CITY OF ALBUQUERQUE

**RE: DaVita Dialysis Center, 5207 San Mateo Blvd.
Grading and Drainage Plan
Plan Dated 4-20-15 for Sheets C2.0-C.2.2; Plan Dated 5-6-2015 for Sheet C5.0
(File: F17-D095A)**

Subject: **Del Norte Dialysis Center, 5207 San Mateo Blvd. NE**
Final Drainage Submittal Response
Project: F17-D095A

C5.0
SHEET 9 OF 12

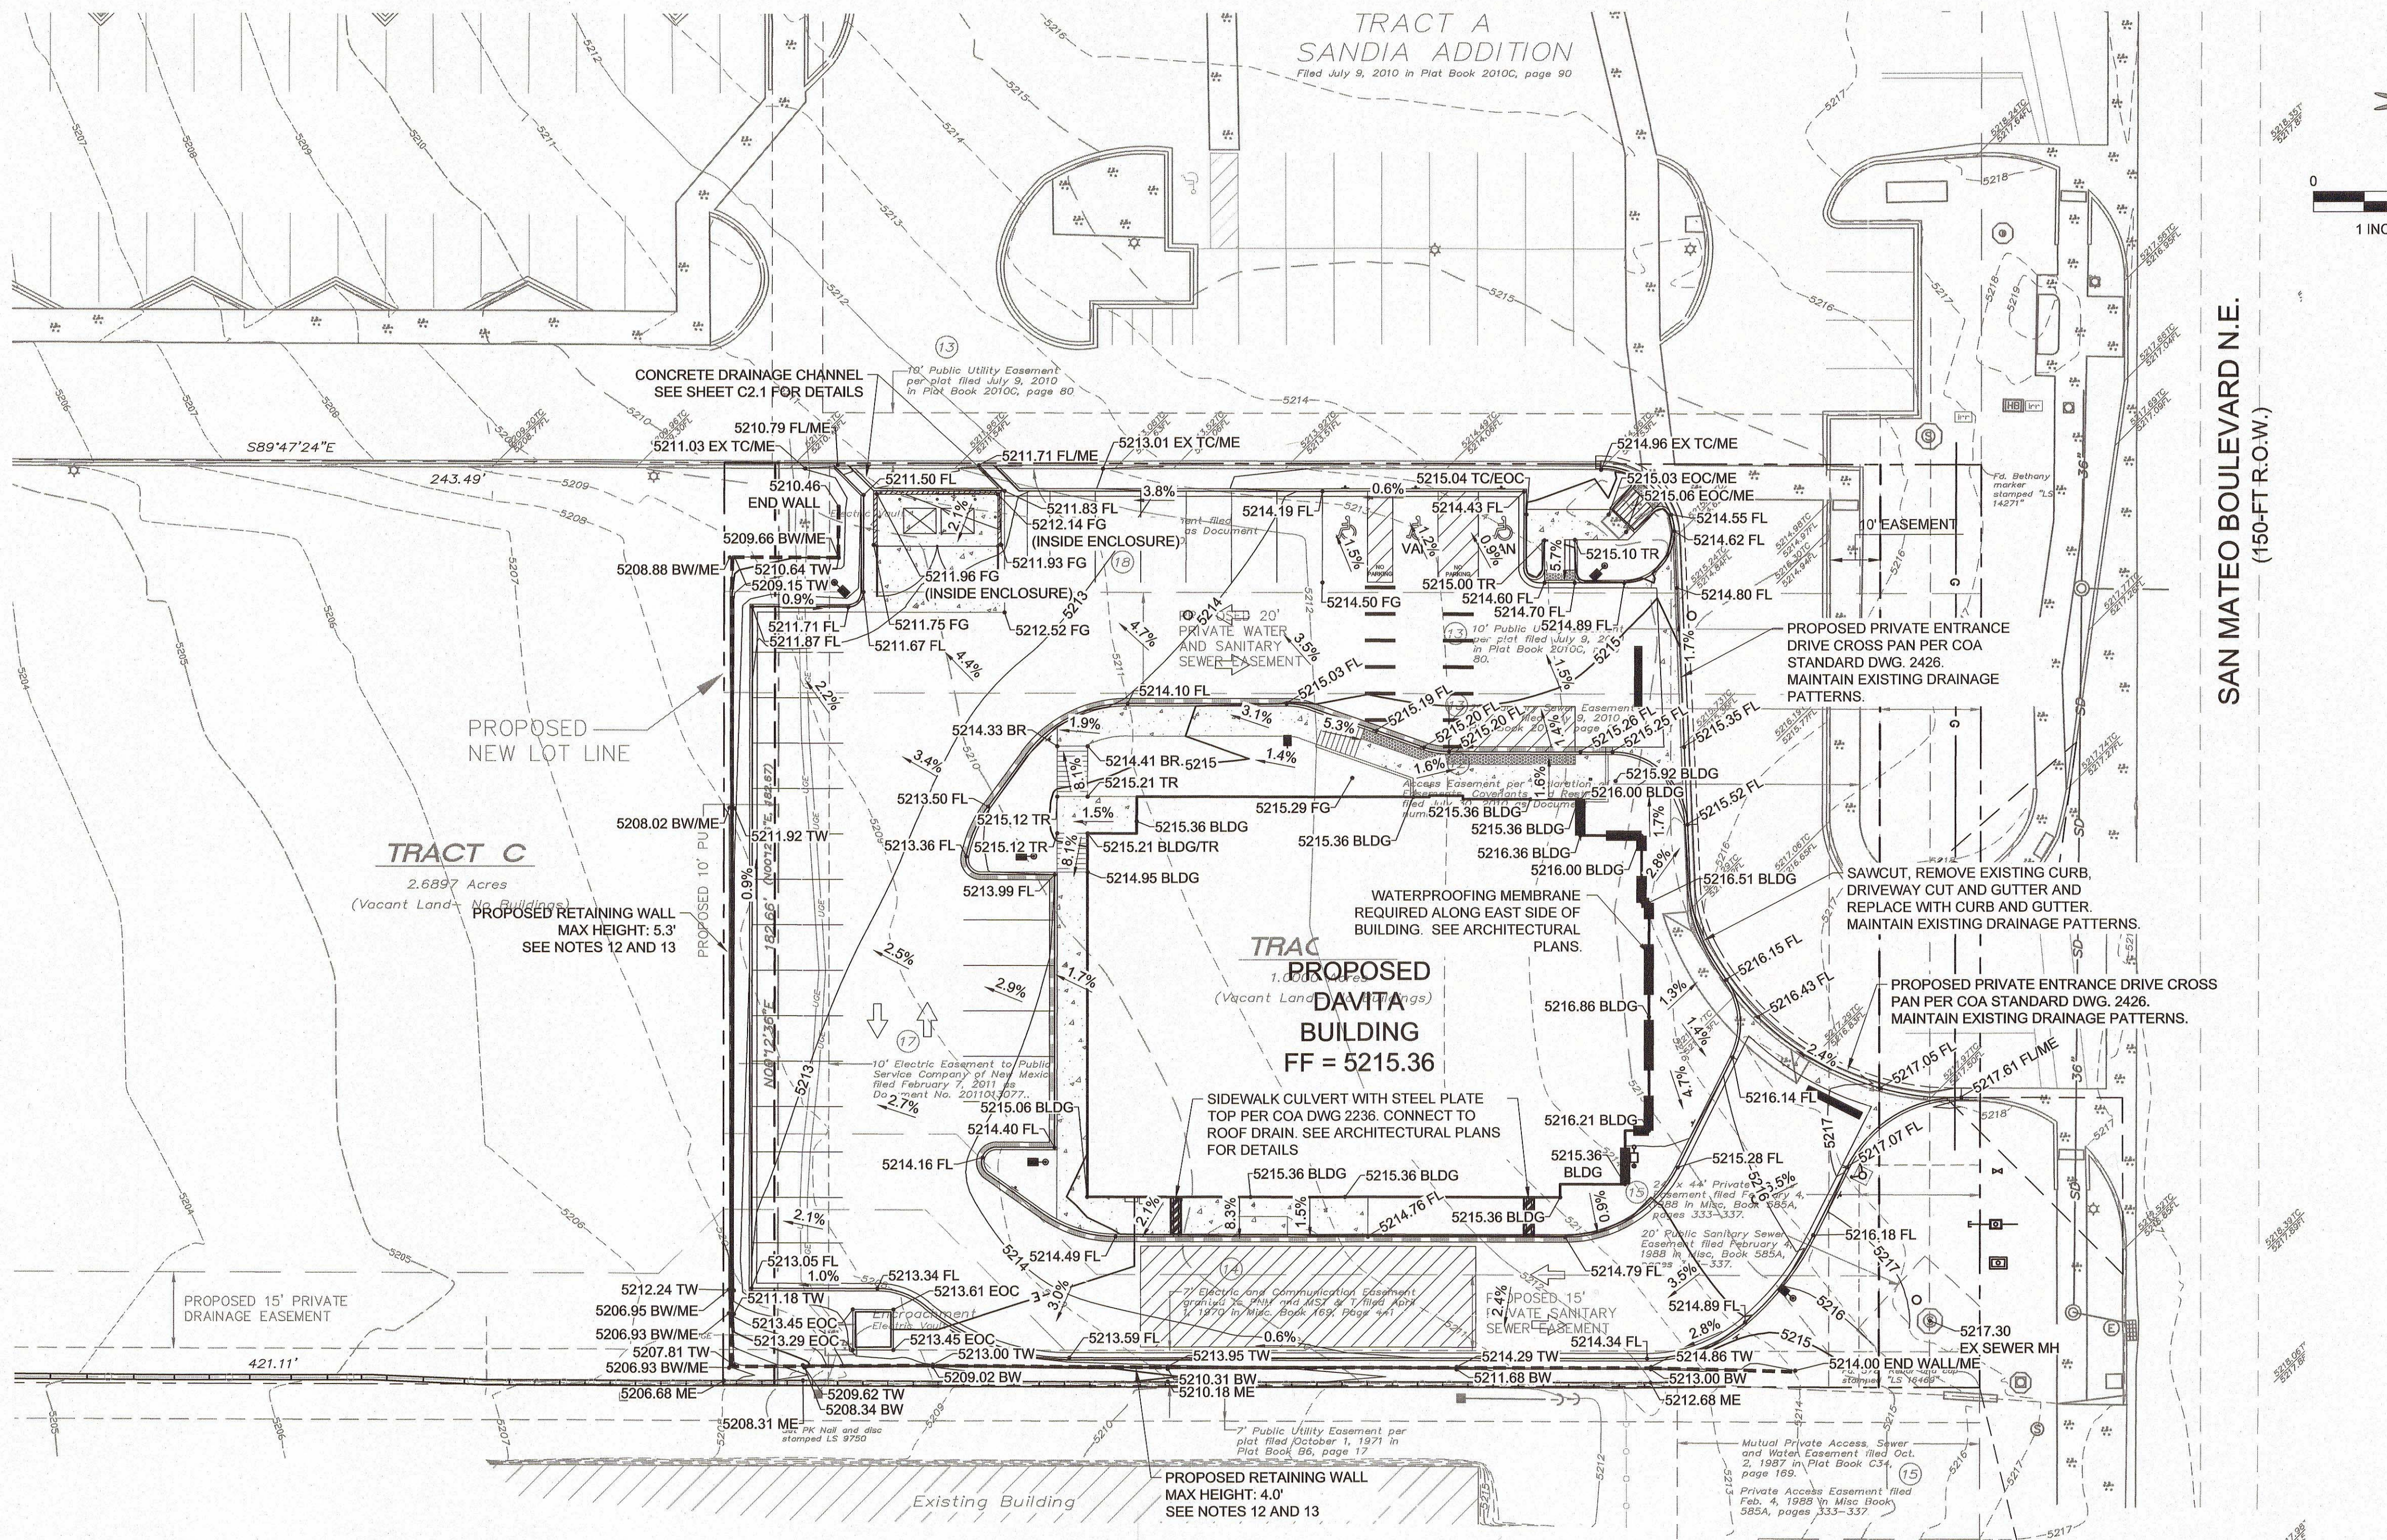
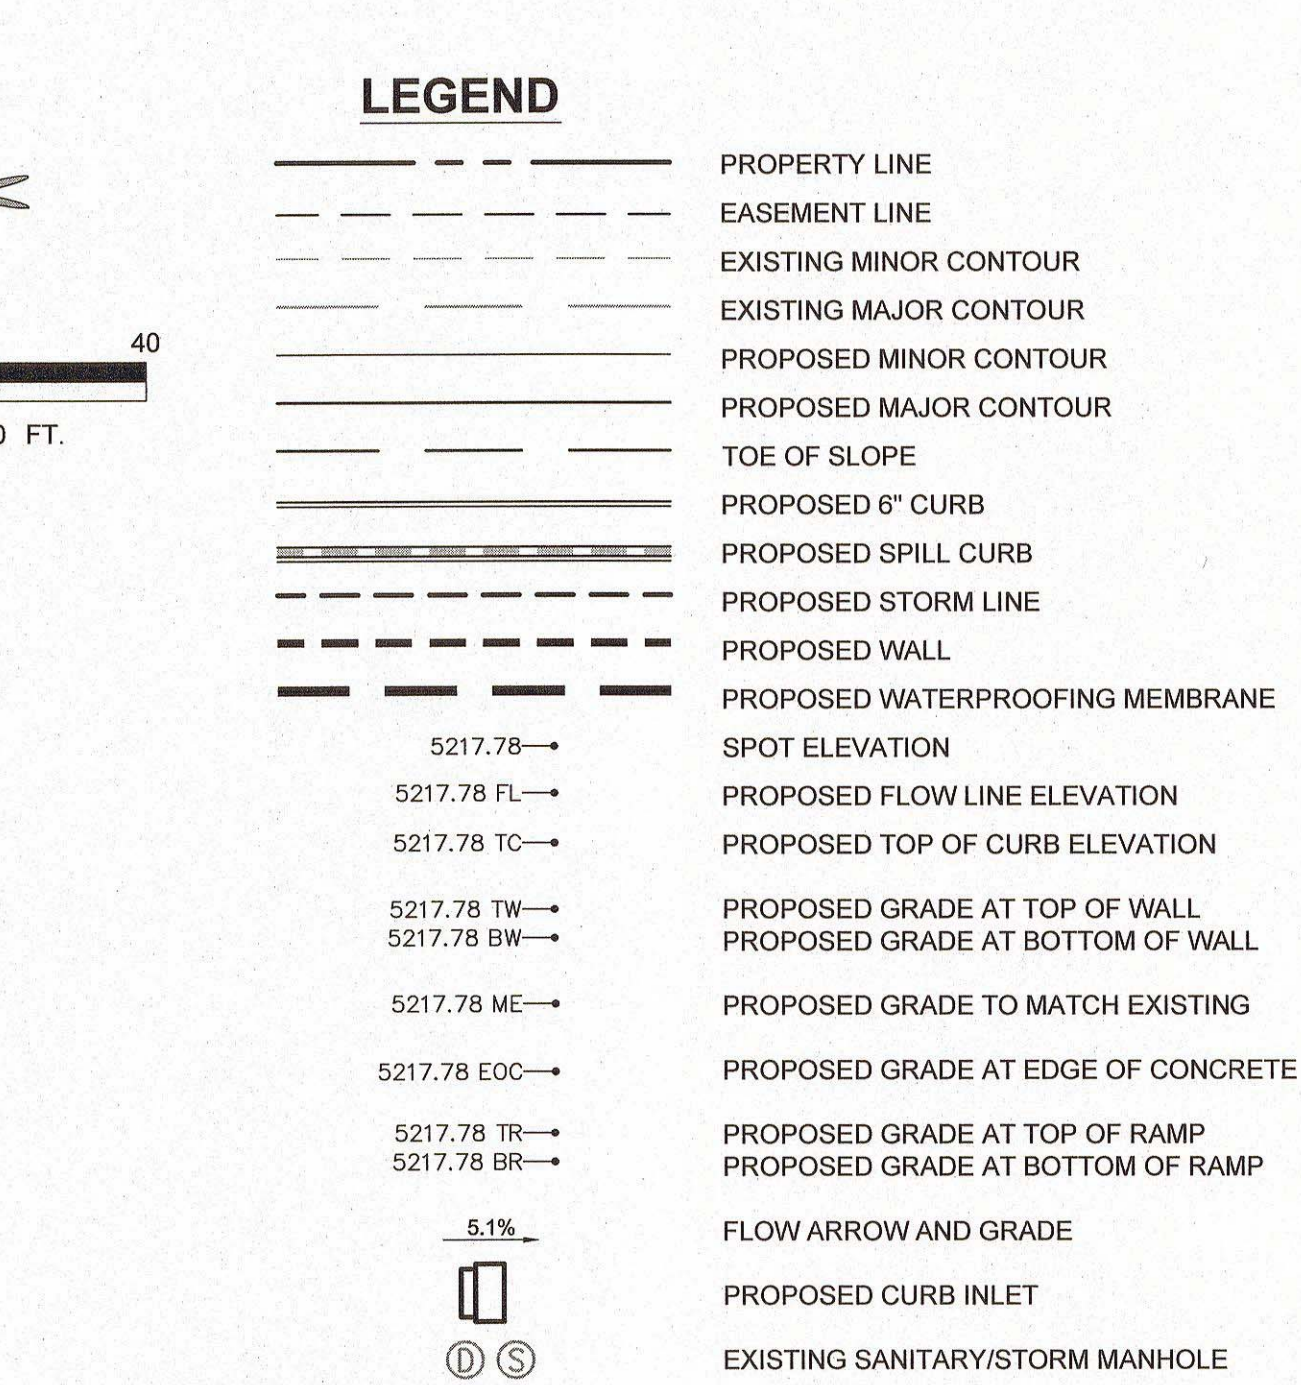
2. On the Sheet C5.0, include your computed WSEL for the 100 year storm, the total volume provided for the storage pond, and the corresponding pond volume at the WSEL.
All information as described above is now shown on Sheet C5.0 in the text box titled Overall North Pond Storage at the top of the sheet.

3. Also, on Sheet C5.0, show all basins that contribute to the north pond which shall include all off-site storm water runoff from the Golden Corral parking lot. **Done. The offsite stormwater tributary to the North Pond is shown as GC3 and this basin was recreated using the Golden Corral Drainage Plan (see report appendix for this plan). Basin GC3 incorporates Basins DA No. 12 & 13 on the Golden Corral Plan.**
